# Access Compliance Report

## Public Rights-of-Way

### (Curb Ramps)

Intersection ID: 14461	Main Street: E_WORTHINGTON_AV	Cross Street: LYNDHURST_AV	Location:	N
ADA ID: 764382383FAD	Ramp Type: Perp	Initial Pass/Fail: Fail	Overall Compliance: No	Severity Score: 1.25

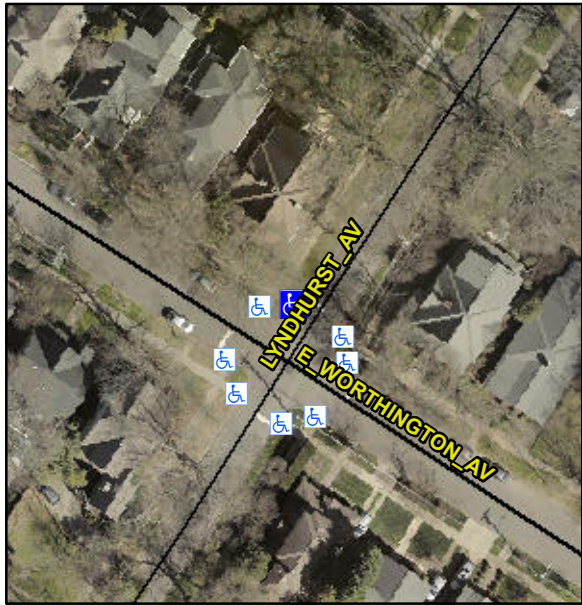
Codes/Mitigation Info/Possible Solution			Field Measurements/Component Compliance									
	Possible Solutions:		<b>Compliance</b>			<b>Description</b>			<b>Data</b>			
	<b>Remove &amp; Replace Entire Ramp.</b>		<b>N/A</b>	Ramp Length (in)		<b>58.0</b>		<b>Yes</b>	Ramp Slope (%)		<b>5.4</b>	
			<b>Yes</b>	Ramp Width (in)		<b>48.0</b>		<b>No</b>	Ramp XSlope (%)		<b>3.3</b>	
			<b>N/A</b>	Flare Type LT		<b>N/A</b>		<b>N/A</b>	Flare Type RT		<b>N/A</b>	
			<b>N/A</b>	Flare Slope LT (%)		<b>N/A</b>		<b>N/A</b>	Flare Slope RT (%)		<b>N/A</b>	
			<b>N/A</b>	Flare Traversable LT?		<b>N/A</b>		<b>N/A</b>	Flare Traversable RT?		<b>N/A</b>	
			<b>N/A</b>	Landing Length (in)		<b>N/A</b>		<b>N/A</b>	DWS Provided?		<b>N/A</b>	
			<b>N/A</b>	Landing Width (in)		<b>N/A</b>		<b>N/A</b>	DWS Contrast?		<b>N/A</b>	
			<b>N/A</b>	Landing Slope (%)		<b>N/A</b>		<b>N/A</b>	DWS Length (in)		<b>N/A</b>	
			<b>N/A</b>	Landing X Slope (%)		<b>N/A</b>		<b>N/A</b>	DWS Full Width?		<b>N/A</b>

Surveyor Notes:		<b>N/A</b>			<b>N/A</b>			DWS Offset (in)			<b>N/A</b>	
PROW/ADA:		<b>Not Found, R304.5.3</b>			<b>N/A</b>							
		<b>N/A</b>			<b>N/A</b>							
		<b>N/A</b>			<b>N/A</b>							
		<b>N/A</b>			<b>N/A</b>							
		<b>N/A</b>			<b>N/A</b>							
		<b>N/A</b>			<b>N/A</b>							
		<b>N/A</b>			<b>N/A</b>							
		<b>N/A</b>			<b>N/A</b>							
		<b>N/A</b>			<b>N/A</b>							
		<b>N/A</b>			<b>N/A</b>							
		<b>N/A</b>			<b>N/A</b>							
		<b>N/A</b>			<b>N/A</b>							
		<b>N/A</b>			<b>N/A</b>							
		<b>N/A</b>			<b>N/A</b>							
		<b>N/A</b>			<b>N/A</b>							
		<b>N/A</b>			<b>N/A</b>							
		<b>N/A</b>			<b>N/A</b>							
		<b>N/A</b>			<b>N/A</b>							
		<b>N/A</b>			<b>N/A</b>							
		<b>N/A</b>			<b>N/A</b>							
		<b>N/A</b>			<b>N/A</b>							
		<b>N/A</b>			<b>N/A</b>							
		<b>N/A</b>			<b>N/A</b>							
		<b>N/A</b>			<b>N/A</b>							
		<b>N/A</b>			<b>N/A</b>							
		<b>N/A</b>			<b>N/A</b>
